INSPECTION REPORT  
Sedimentation Structure  
N2-G  
Kayenta Mine  
Navajo County, Arizona  
for  
PEABODY COAL COMPANY

Dames & Moore  
10139-011-22

# SITE PLAN N2-G

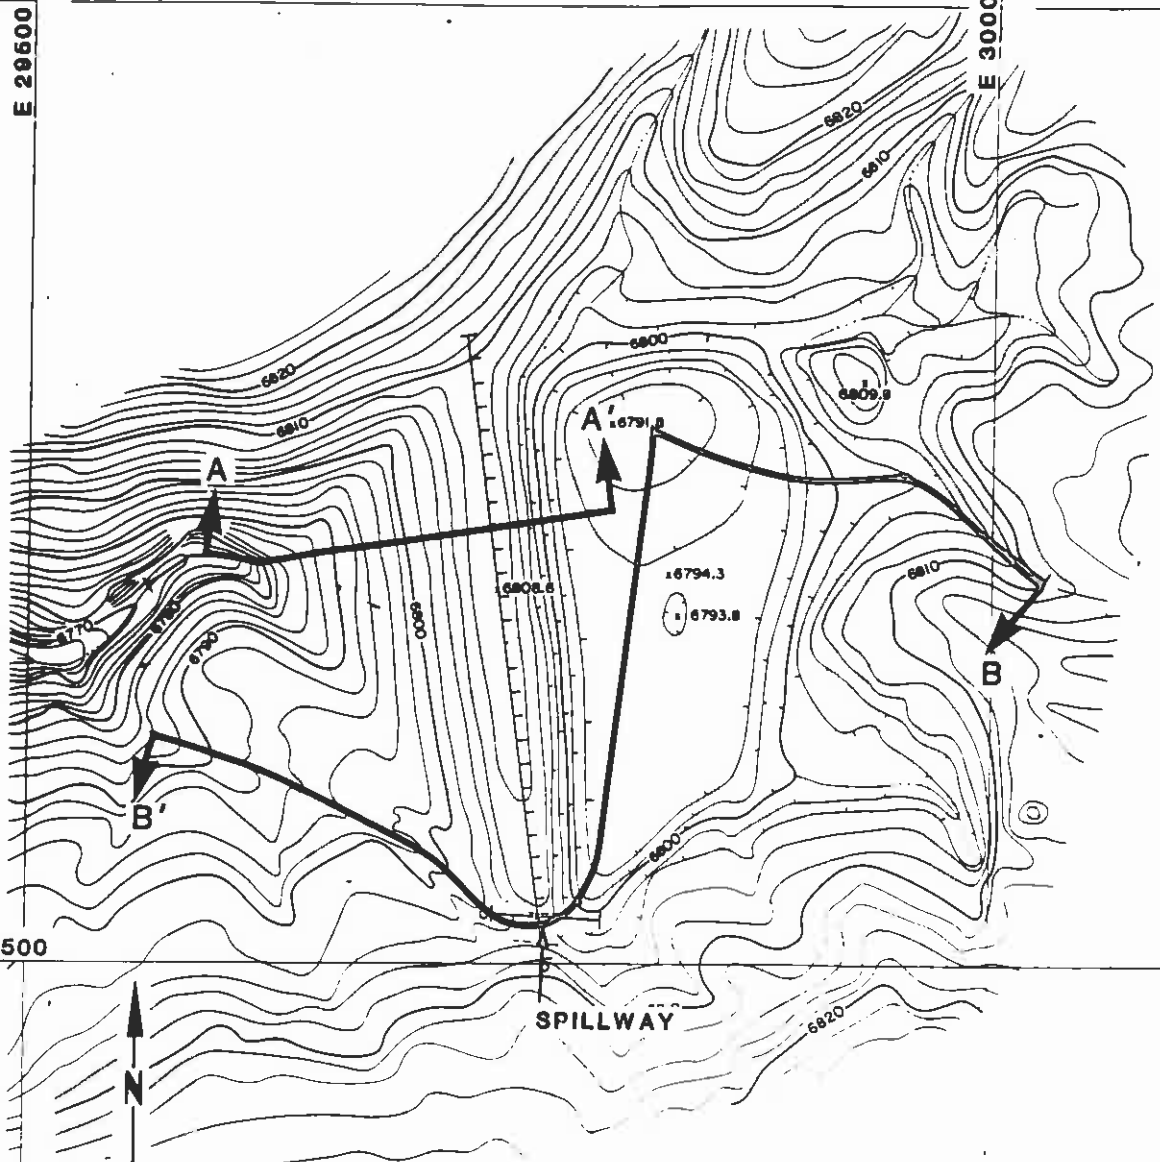
The storage capacity and spillway capacity of Structure N2-G are adequate; however, the spillway does not have an adequate outflow channel or adequate erosion protection. A trapezoidal outflow channel should be constructed along the alignment B-B' shown in Plate 1. The channel profile is shown in Plate 4 and the required dimensions are shown in Plate 5. Both the spillway and outflow channel should be protected against erosion using geotextile and gravel as shown in Plate 5.
